Access Compliance Report

Public Rights-of-Way

Intersection ID: 8206	Main Street: BURBANK_DR	Cross Street: SOUTHWEST_BV	Location: SW
ADA ID: 081278FFABF7	Ramp Type: Perp	Initial Pass/Fail: Fail	Overall Compliance: No
Severity Score: 8.75			
Codes/Mitigation Info/Possible Solution		Field Measurements/Component Compliance

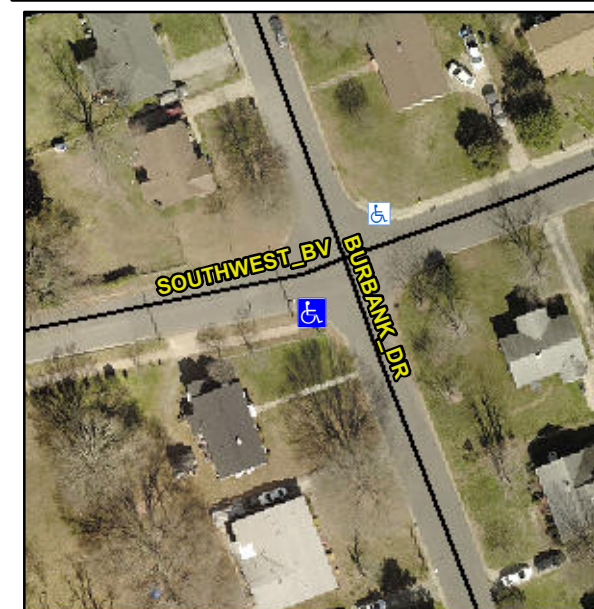
Not Found, R304.5.1

Compliance	Description	Data	Compliance	Description	Data
N/A	Ramp Length (in)	80.0	Yes	Ramp Slope (%)	5.4
No	Ramp Width (in)	40.0	Yes	Ramp XSlope (%)	1.3
N/A	Flare Type LT	N/A	N/A	Flare Type RT	N/A
N/A	Flare Slope LT (%)	N/A	N/A	Flare Slope RT (%)	N/A
N/A	Flare Traversable LT?	N/A	N/A	Flare Traversable RT?	N/A
N/A	Landing Length (in)	N/A	N/A	DWS Provided?	N/A
N/A	Landing Width (in)	N/A	N/A	DWS Contrast?	N/A
N/A	Landing Slope (%)	N/A	N/A	DWS Length (in)	N/A
N/A	Landing X Slope (%)	N/A	N/A	DWS Full Width?	N/A
N/A	Landing Curb? (Y/N)	N/A	N/A	DWS Offset (in)	N/A
N/A	Shared Landing?	N/A			
N/A	Gutter Ponding?	N/A	N/A	Gutter Slope (%)	N/A
N/A	Gutter Lip Ht (in)	N/A	N/A	Gutter X Slope (%)	N/A
N/A	Painted X Walk1?	No	N/A	Painted X Walk2?	N/A
	X Walk 1 Direction	To E		X Walk 2 Direction	N/A
N/A	X Walk 1 Width (in)	N/A	N/A	X Walk 2 Width (in)	N/A
	X Walk 1 Slope (%)	5.7		X Walk 2 Slope (%)	N/A
	X Walk 1 X Slope (%)	4.5		X Walk 2 X Slope (%)	N/A

Remove & Replace Entire Ramp.
